# FCC ID QIPELS81-US Pcb Comparison for C2PC

**Intel 2019-05-13**

# S11 – Return Loss

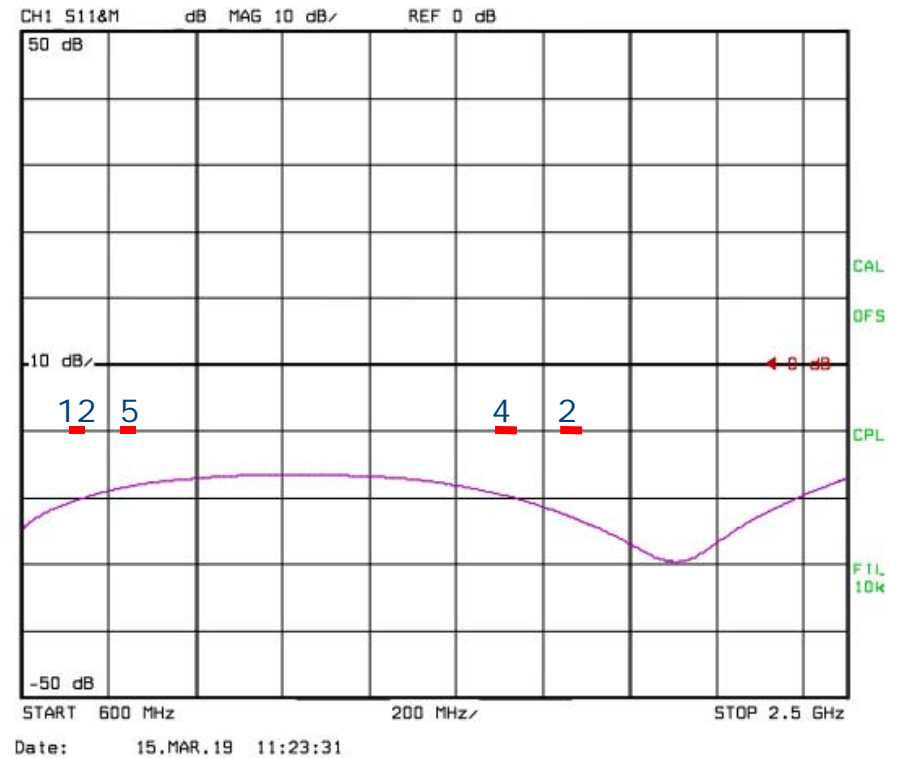
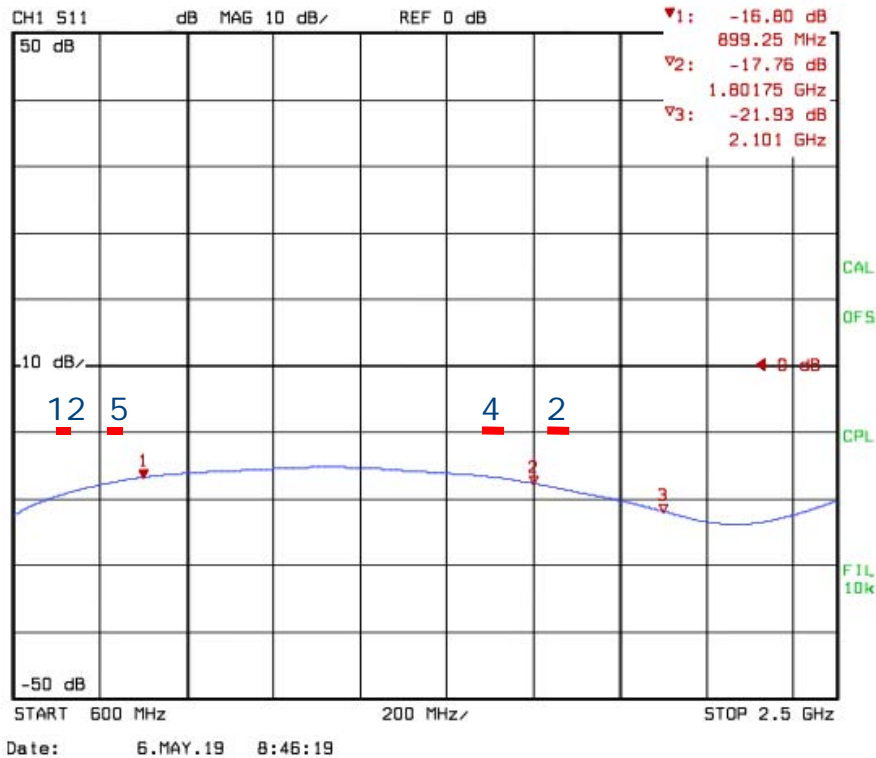
Initial Submission PCB → C2PC request PCB

- S11 – Return Loss – Impedance Adaptation is in both case below -17dB so very good adaptation → no significant difference and impact on transmitted / received signal
- S21 – Path Loss difference is less than 0.1-0.2dB that is also non significant for transmitted/received signal
- Variant PCB RF Traces are designed following guidance from module vendor and don't show significant difference

# S21 – Path Loss

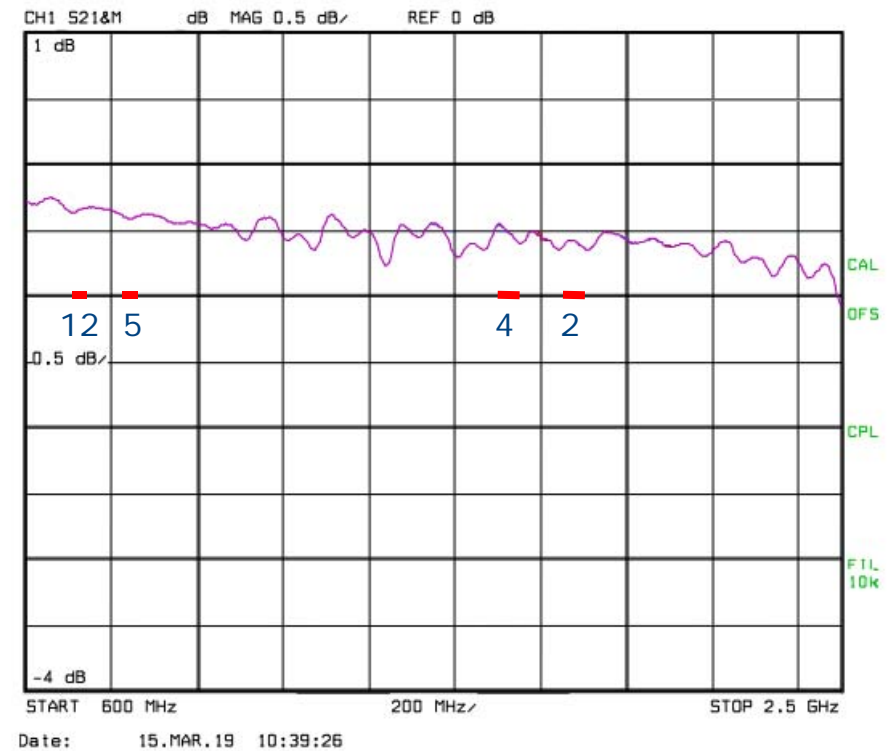
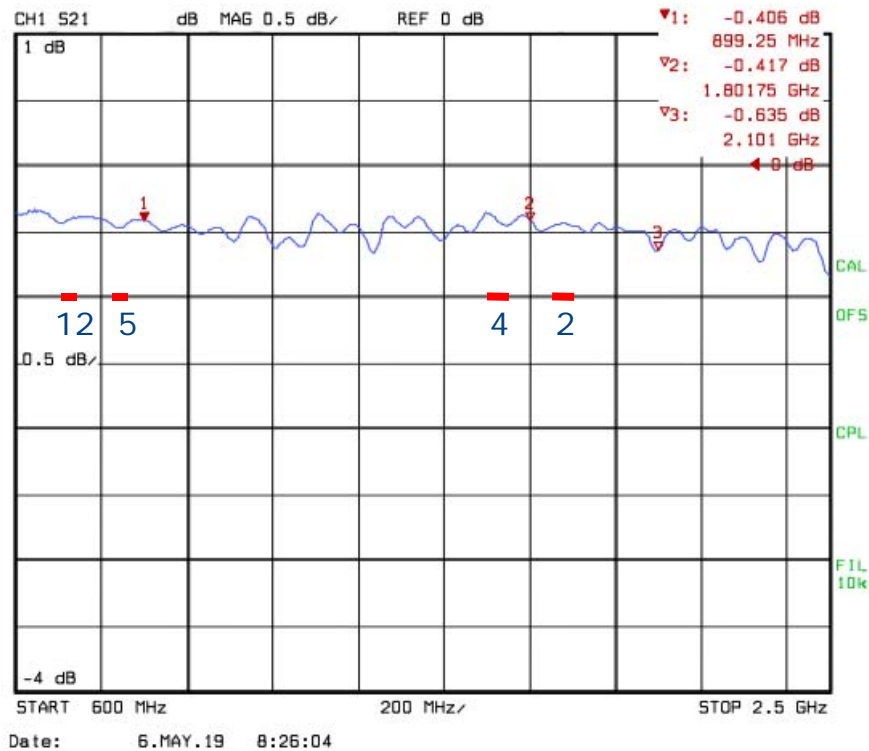
Initial Submission PCB → C2PC request PCB
